October 24, 2003

SUBJECT: PALO VERDE NUCLEAR GENERATING STATION, UNITS 1, 2, AND 3 -
ISSUANCE OF AMENDMENTS ON THE CORE PROTECTION CALCULATOR
SYSTEM UPGRADE (TAC NOS. MB6726, MB6727, AND MB6728)

The Commission has issued the enclosed Amendment No. 150 to Facility Operating License No. NPF-41, Amendment No. 150 to Facility Operating License No. NPF-51, and Amendment No. 150 to Facility Operating License No. NPF-74 for the Palo Verde Nuclear Generating Station, Units 1, 2, and 3, respectively. The amendments consist of changes to the Technical Specifications (TSs) in response to your application dated November 7, 2002 (102-04864), as supplemented by letters dated April 25 (102-04931), July 10 (102-04964), July 30 (102-04976), August 13 (102-04985), September 18 (102-04995), and October 1 (102-05006), 2003.

Figure 1 Existing CPCS

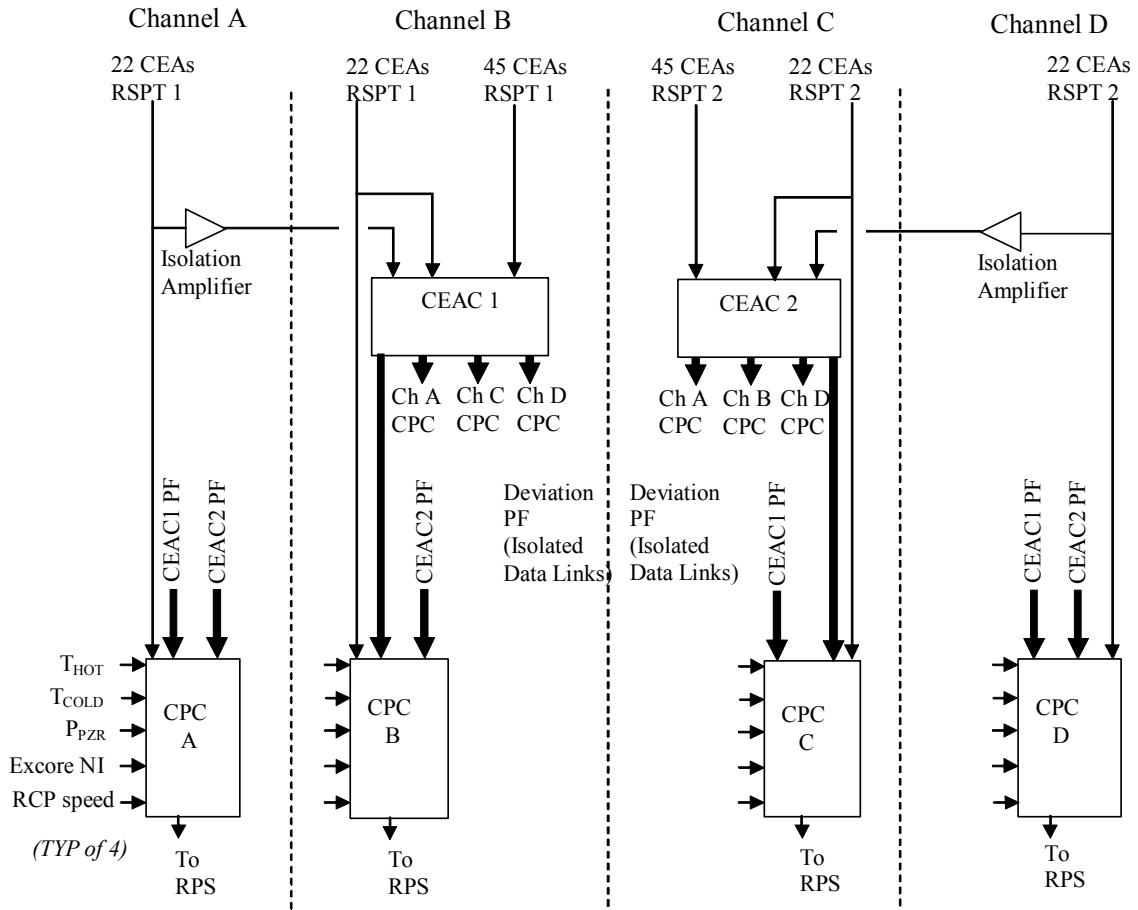
The licensee proposes to replace the existing CPCS (see Figure 1, page 10) with a new functionally equivalent Common Q system to be located in the existing CPC racks and cabinets. Figure 1 was drawn by the NRC staff from its review of the proposed change to the CPCS.

Figure 2 Proposed CPCS

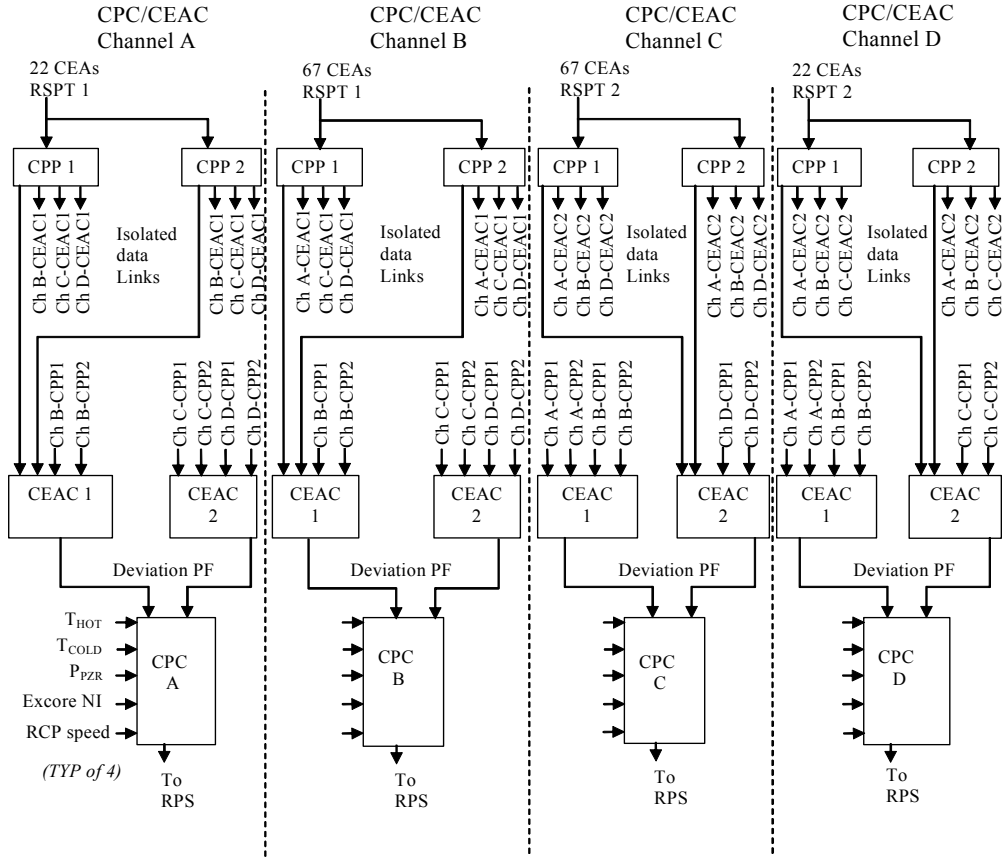
The implementation of the proposed CPCS Common Q system is shown in Figure 2, page 11. Figure 2 was also drawn by the NRC staff from its review of the proposed change to the CPCS.

The CPC system is comprised of four redundant channels (A,B,C and D), as shown in Figure 2, that perform the necessary calculation, bistable, and maintenance functions. The system includes four redundant operator modules (OM), one per CPC/CEAC channel, located in the main control room. One CPC/CEAC channel is located in each auxiliary protective cabinet (APC)—as in the present design—where the channels are separated and electrically isolated from one another. Each channel APC also contains a maintenance and test panel (MTP) for routine testing. A CPC/CEAC channel is associated with each RPS channel and provides low DNBR and LPD trip and pretrip signals and CEA withdrawal prohibit (CWP) outputs to its associated RPS channel. The four redundant channels are designed to satisfy the single failure criteria. The CPC and CEAC processors in each channel receive process analog signals from hot leg (T_{hot}) and cold leg (T_{cold}) temperature, pressurizer pressure (P_{PZR}), ex-core neutron flux, and reactor coolant pump (RCP) speed and RSPTs. These parameters are used in the safety-related application software algorithms performed by the CPC and CEAC processors. The existing field sensors and RPS inputs will be used in the proposed design.

Figure 2 does not show the interface between each CPC channel and the RPS. Each CPC channel will interface with the RPS through an interposing relay panel (IRP) which will contain interposing relays for each digital output (DO) contact from the CPCS. The IRPs are located in the auxiliary protective cabinets. These relays, Phoenix PLC-RSC-24DC/21-21, provide the electrical interface between the CPC channel and the RPS. All contact output signals are routed through these relays on the IRP. The IRP also houses the Watchdog Timer (WDT) output interposing relay used to provide Low DNBR and High LPD trip outputs on WDT timeout. The IRPs are located in the corresponding Channels A and C.

Figure 3 Connectivity to non-safety related systems

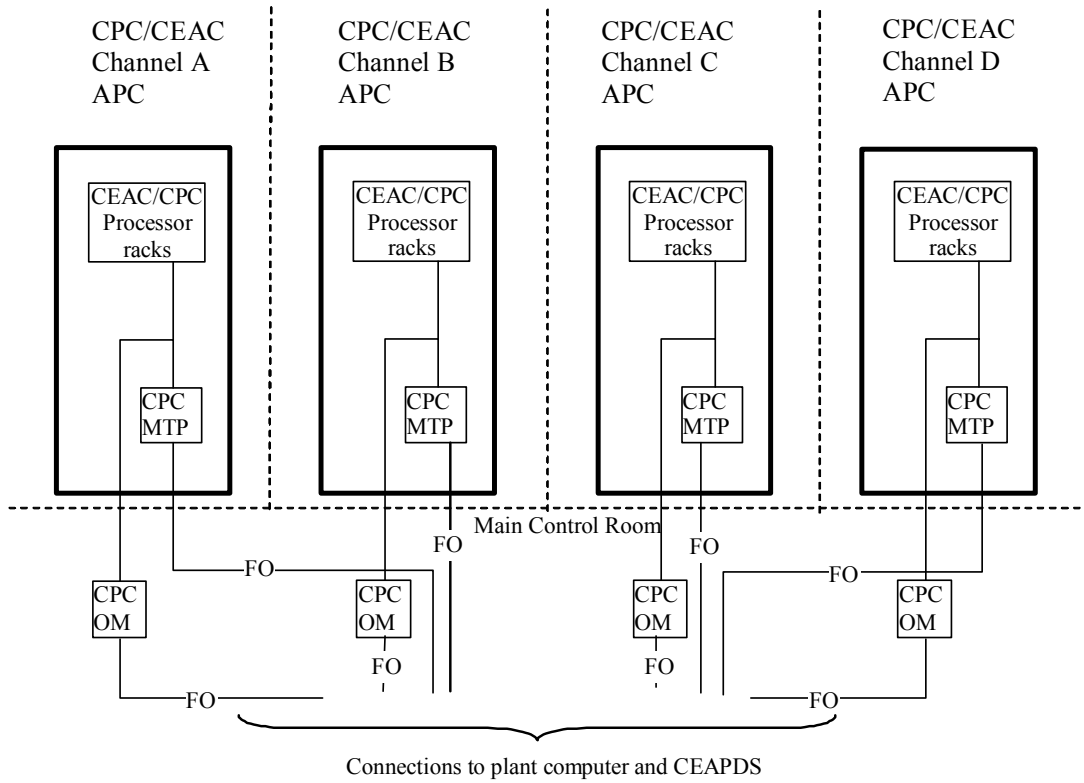
Figure 3 (on page 14) illustrates the CPCS connectivity with non-safety related systems including the plant computer and the CEAPDS. The figure was drawn by the NRC staff from its review of the proposed changes to the CPCS.

Connections to these systems are made using fiber optic (FO) links. The MTP and OM uses the Transmission Control Protocol/Internet Protocol; therefore, one-way communication is accomplished at the application layer of the open systems interconnection (OSI) 7-layer communication model. Communication handshaking does occur at the lower levels of the OSI model and is handled at the Ethernet interface card. The I/O interface provides a buffer circuit which separates the plant computer/CEAPDS link and the communication functions that occur between the OM/MTP, and the CPC and CEAC processors.
